#### ADDENDUM NO. 7

**June 6, 2022**

# LIBERTY INTERMEDIATE SCHOOL ADDITIONS AND RENOVATIONS

This Addendum consists of Pages ADD 7-1 through ADD 7-4 and attached Addendum No. 7 from Gibraltar Design dated June 6, 2022 and consisting of 5 pages and 75 drawings.

MD104

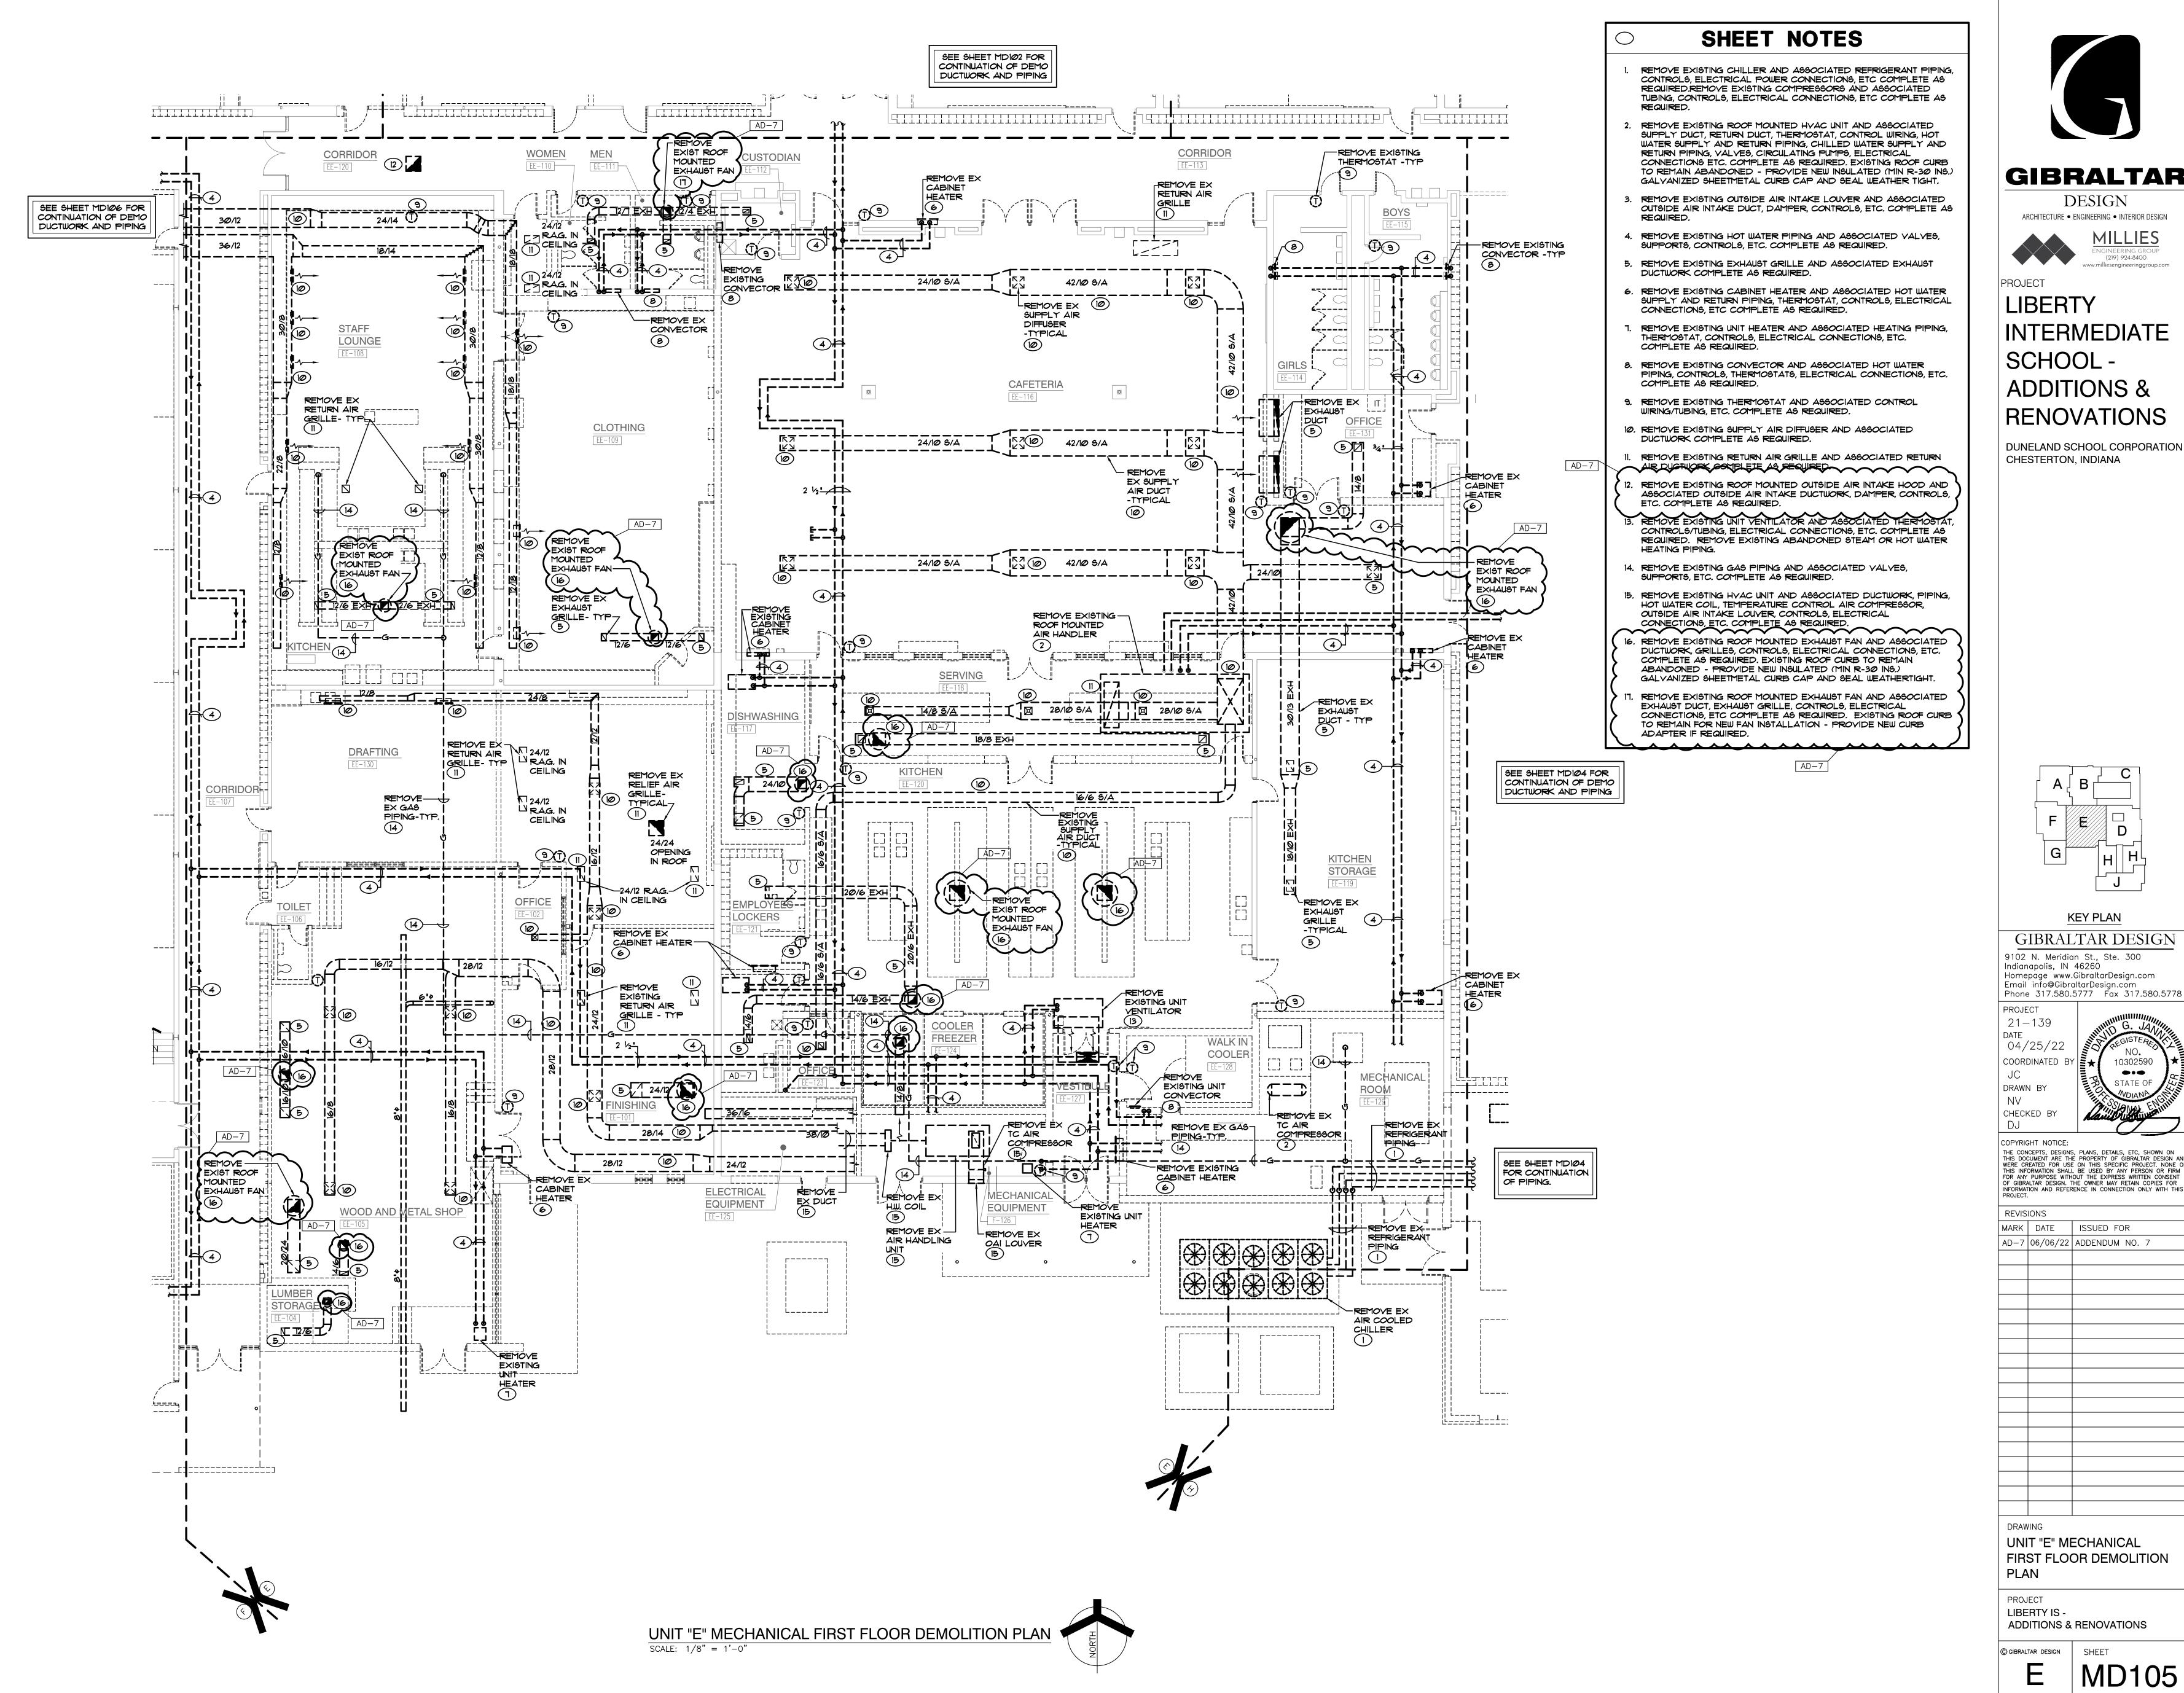
- A. Refer to revised full-size drawing included in this Addendum, for the following revisions:
  - 1. Added demo exhaust fans.
  - 2. Added sheet note 19, 20, 21.
  - 3. Added existing relief.
  - 4. Revised louver from demo to existing to remain.

MD105

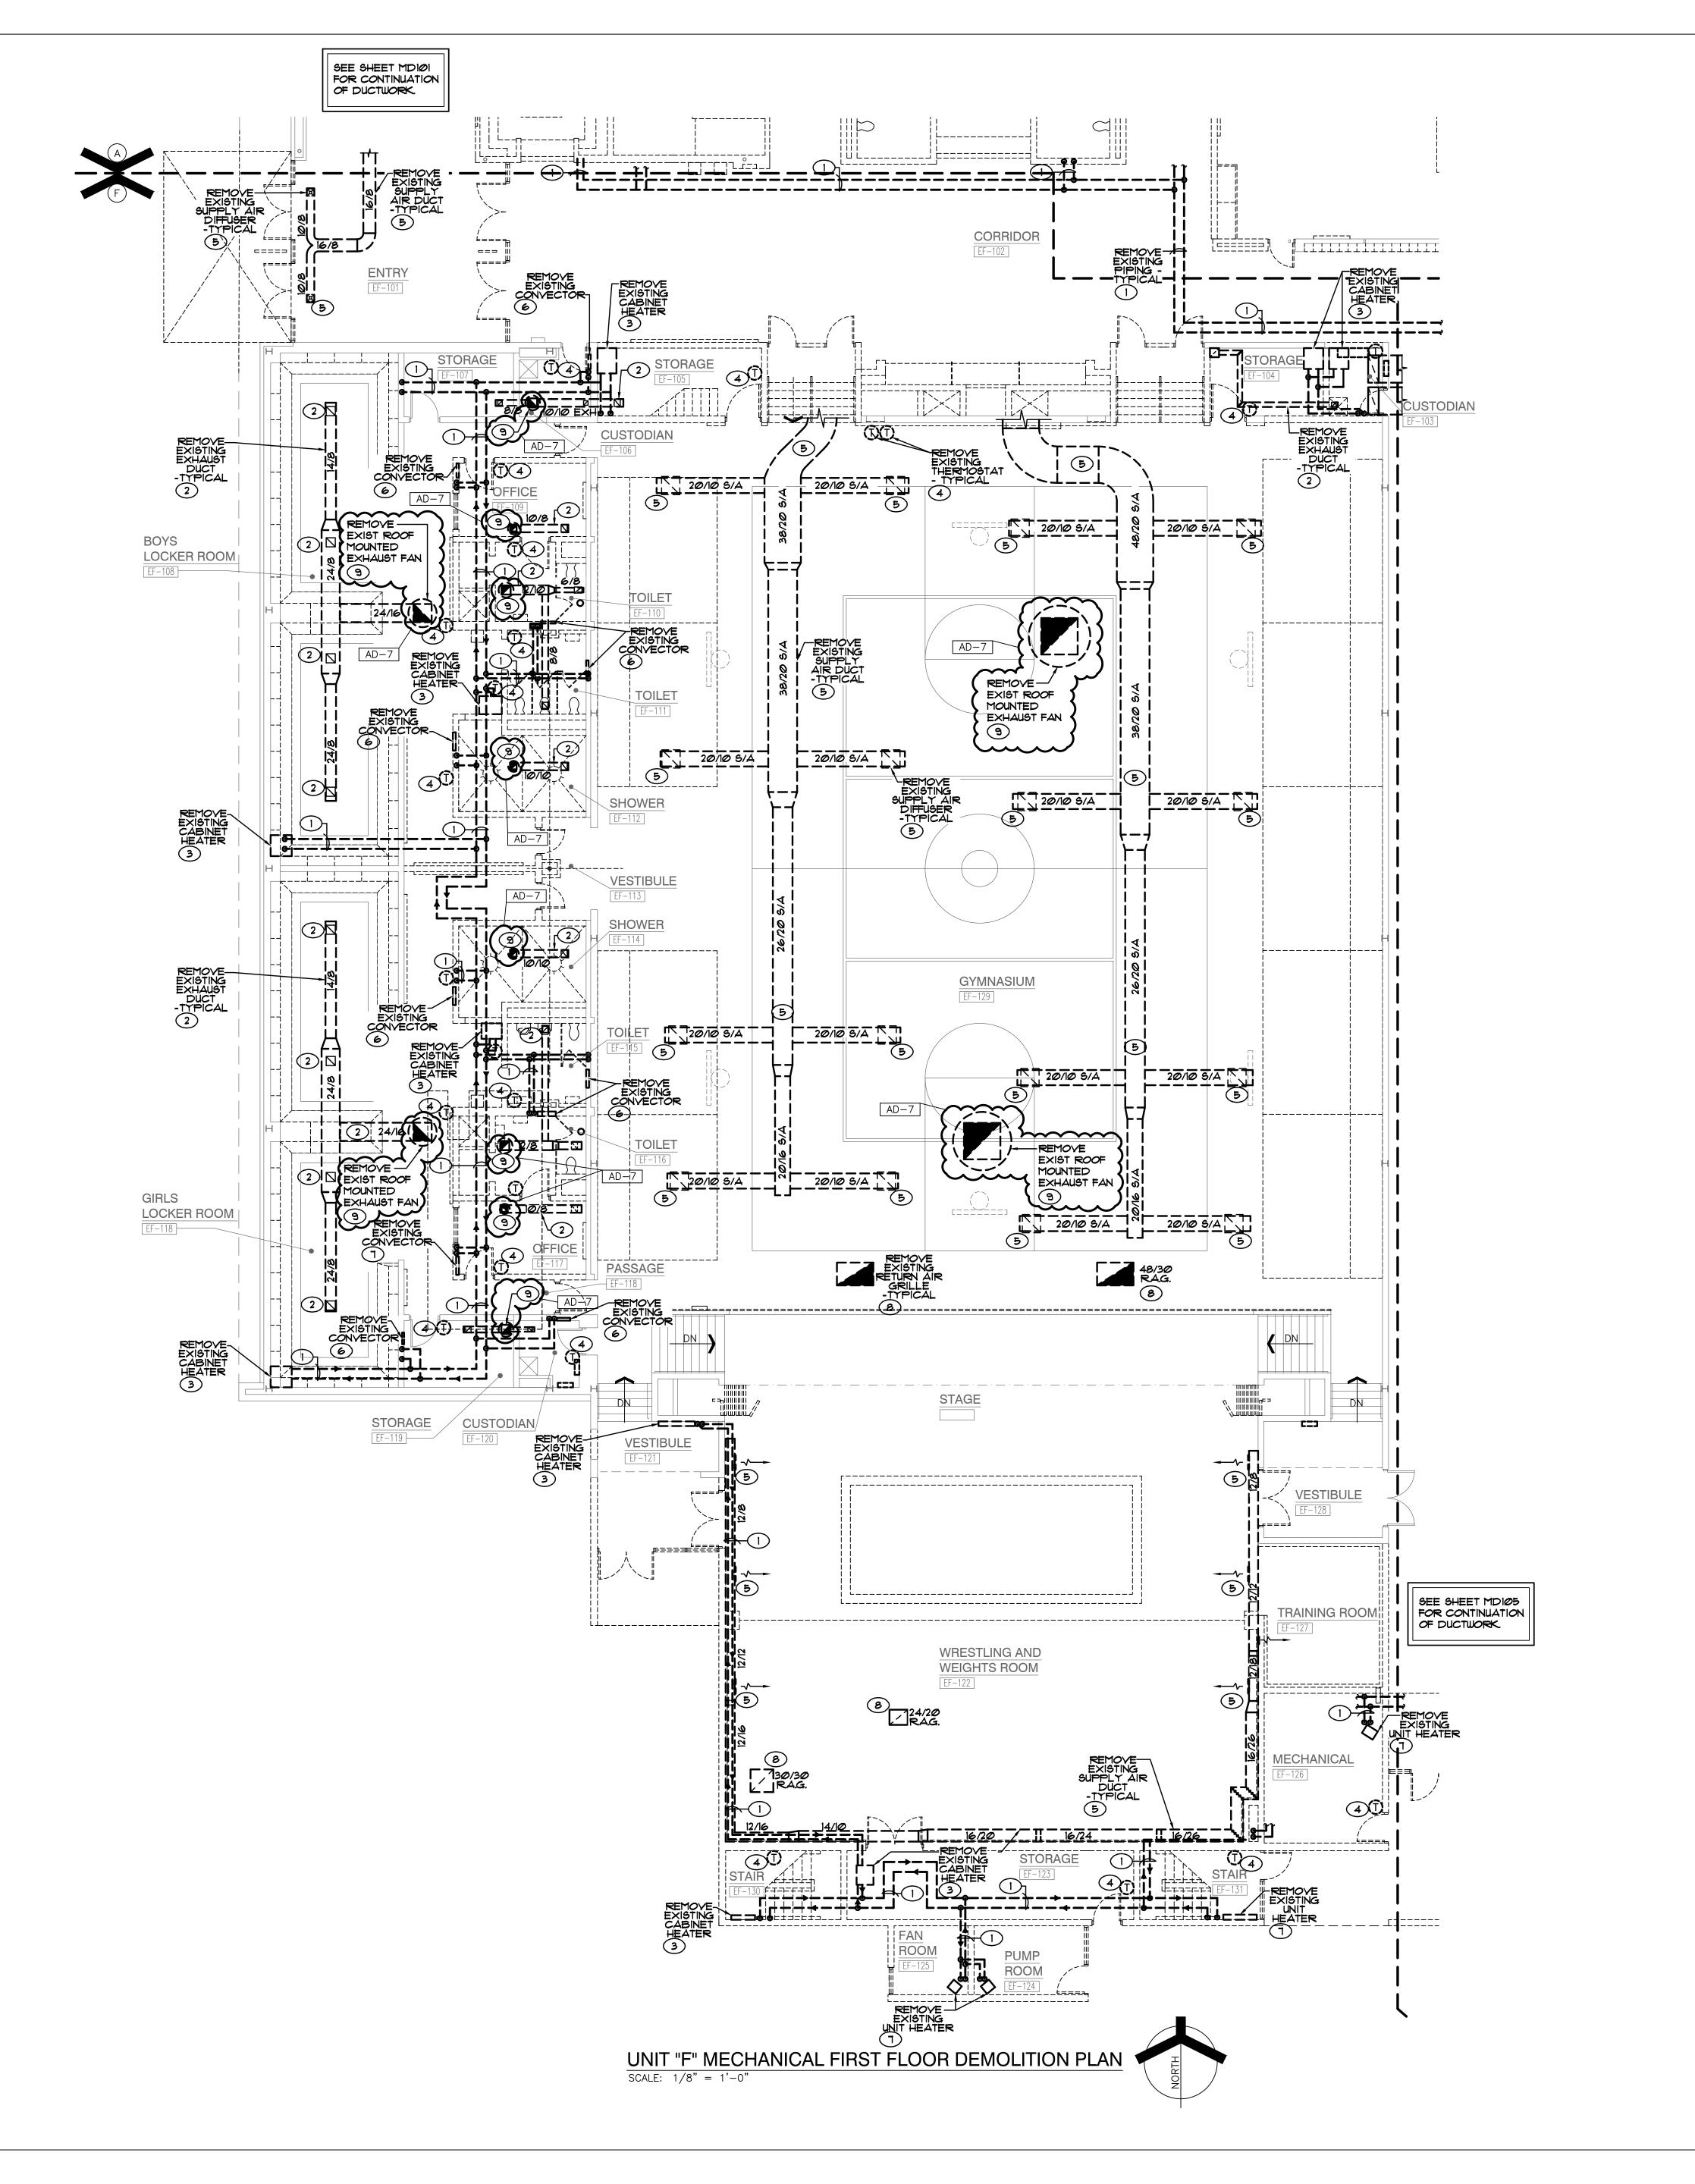
- A. Refer to revised full-size drawing included in this Addendum, for the following revisions:
  - 1. Added demo exhaust fans.
  - 2. Added sheet note 16 and 17.
  - 3. Revised sheet note 12.

MD106

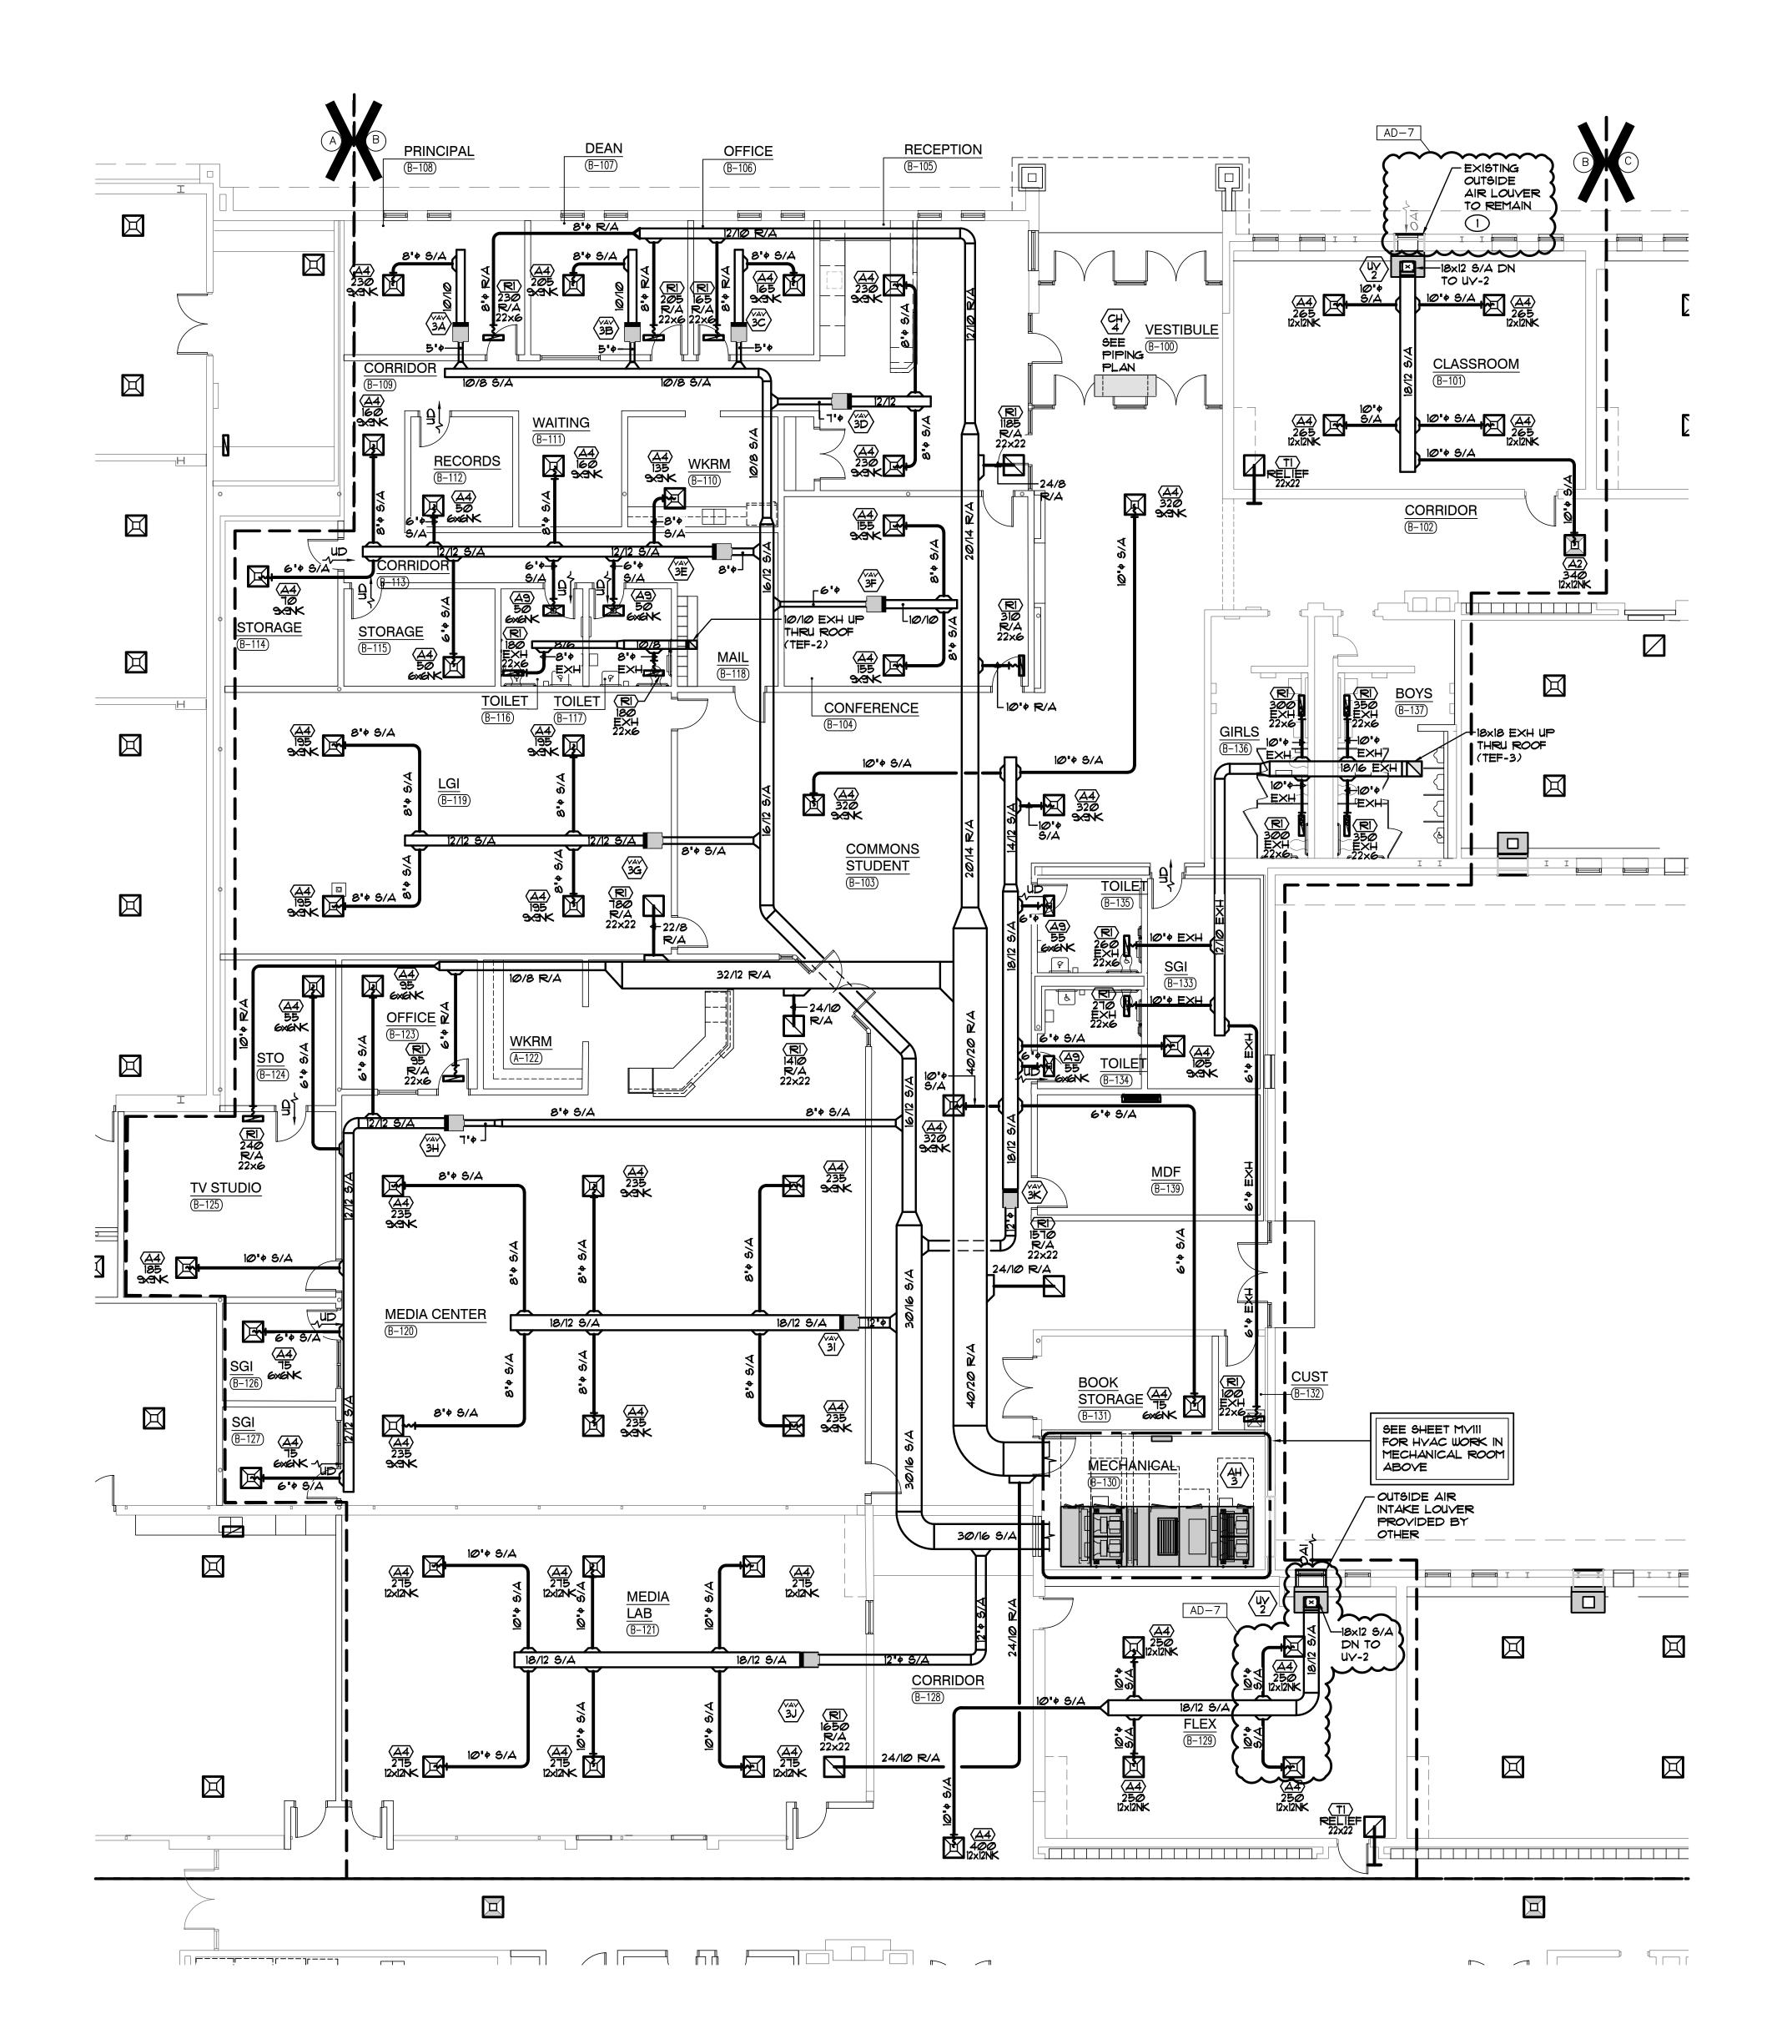
- A. Refer to revised full-size drawing included in this Addendum, for the following revisions:
  - 1. Added demo exhaust fans.
  - 2. Added sheet note 9.
